Steven M. Clouse WRC Headworks Enhancements Phase 2 Project
Solicitation No.: CO-00402-SM
Job No: 19-6504

ADDENDUM 1
May 25, 2021

RESPONSES TO QUESTIONS

GRIT REMOVAL FACILITY SECTIONS
(1 OF 2)

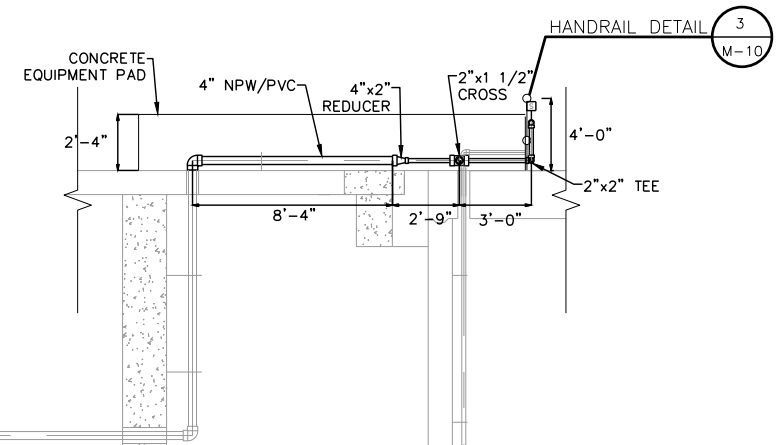
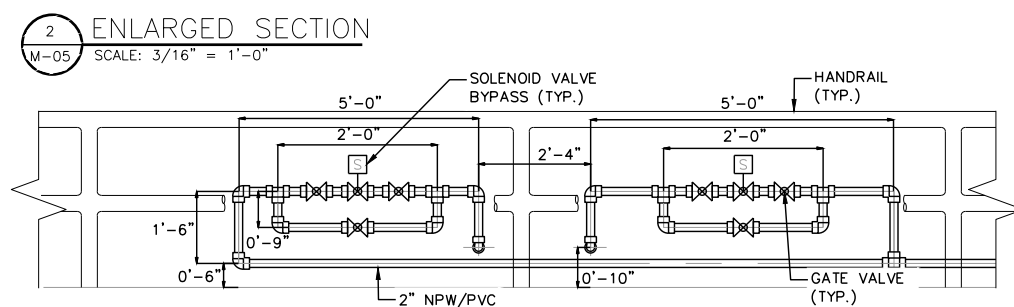
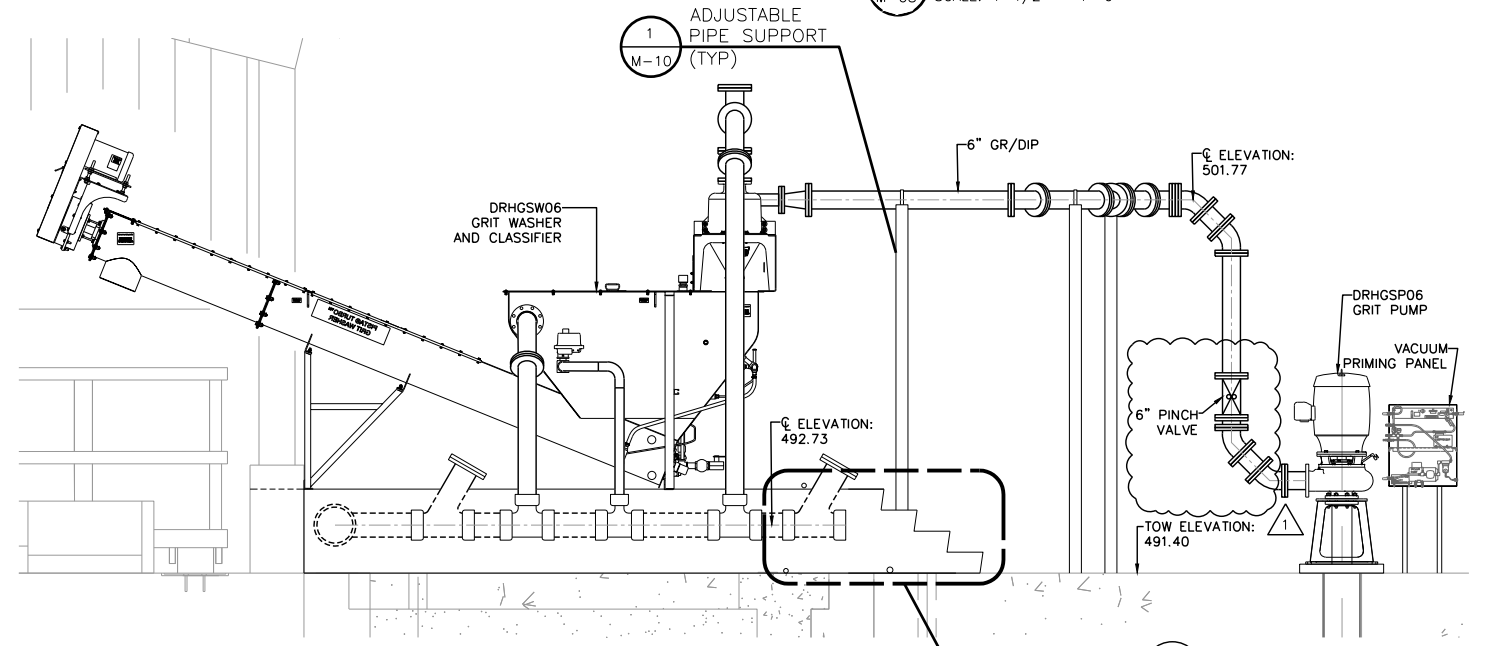
- c) For the Grit Pumps, the issue is basically the same. We need to know how many, what size, what spec and which items are included/excluded by S/L.**

Response: Each grit pump includes a 6-inch Pinch Valve that will be provided by S&L and installed by the Contractor. Sheet M-08 was updated to show the 6-inch Pinch Valve.
